01 Floor plans

Level 09 Floor Plan

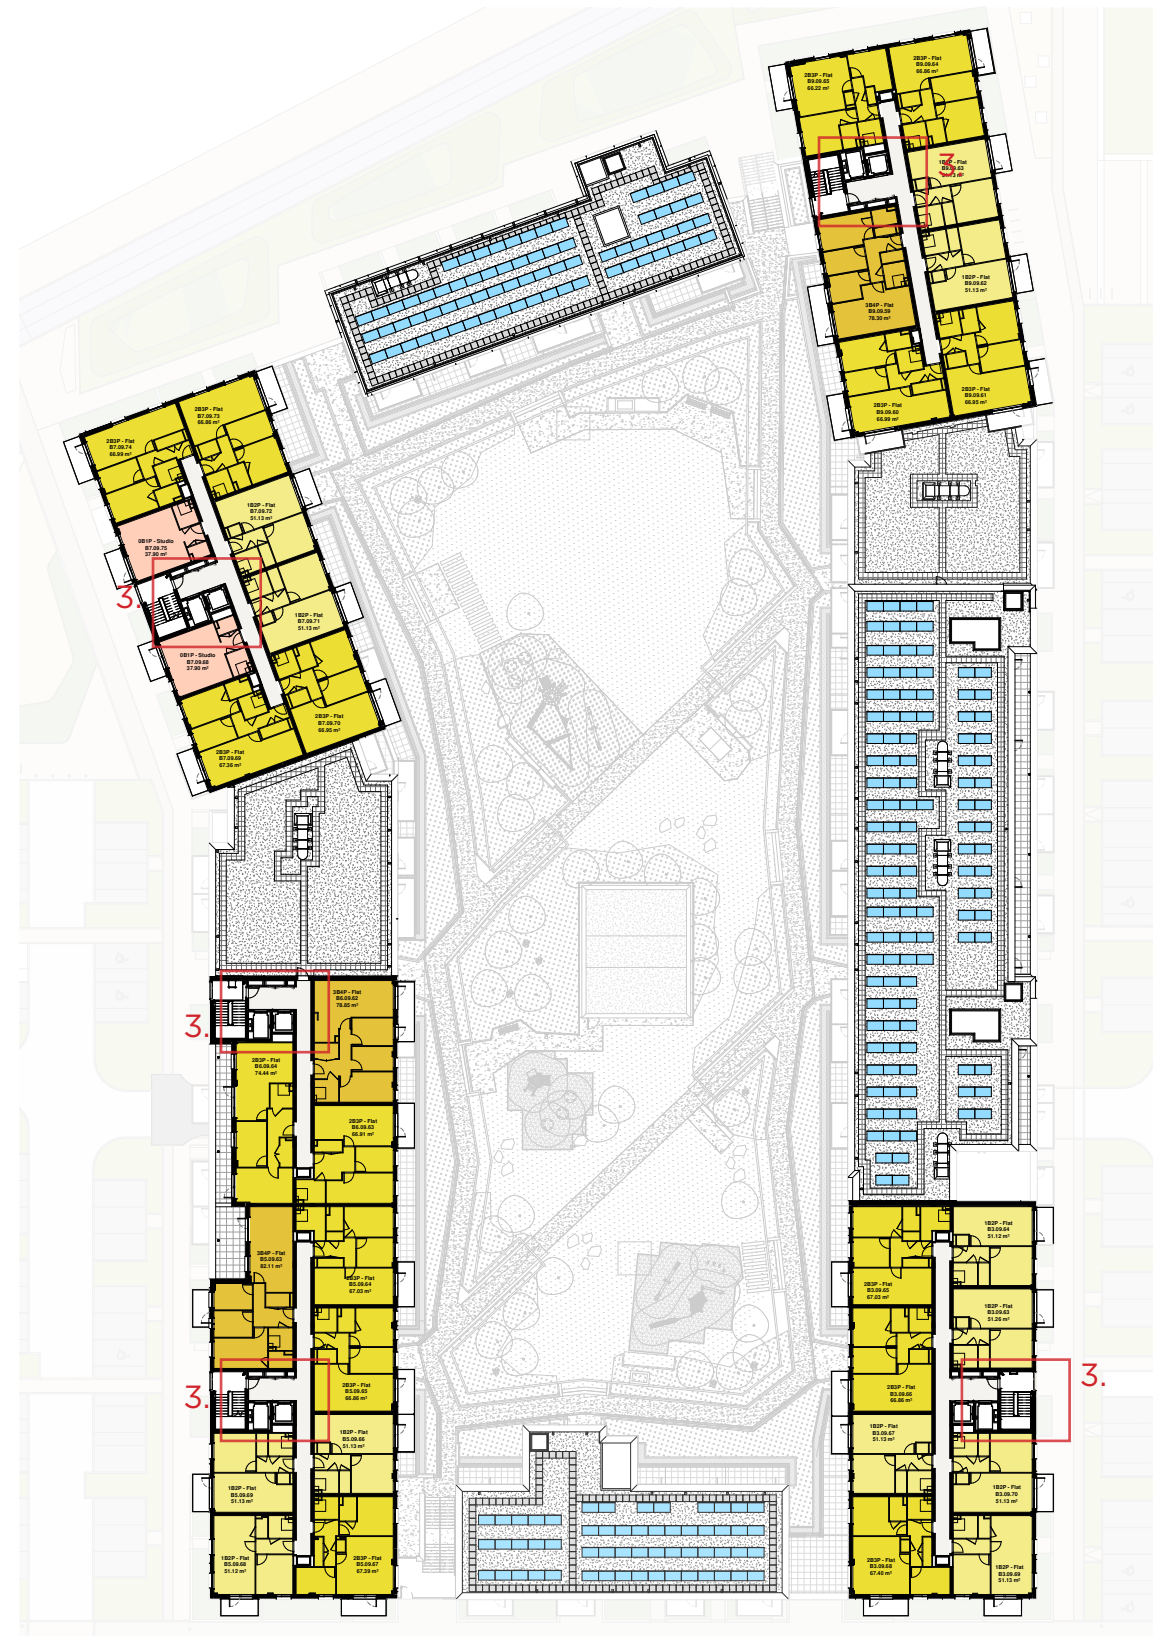
1. Omission of podium entrance canopies; security risk to adjacent apartments at first floor.
2. Addition of plant housing for car park smoke extract fans as per developed fire strategy
3. Updated core layout as per developed fire strategy; evacuation lifts added to Blocks 4 and 8
4. Reconfiguration of apartment layout. Overall mix remains as consented.
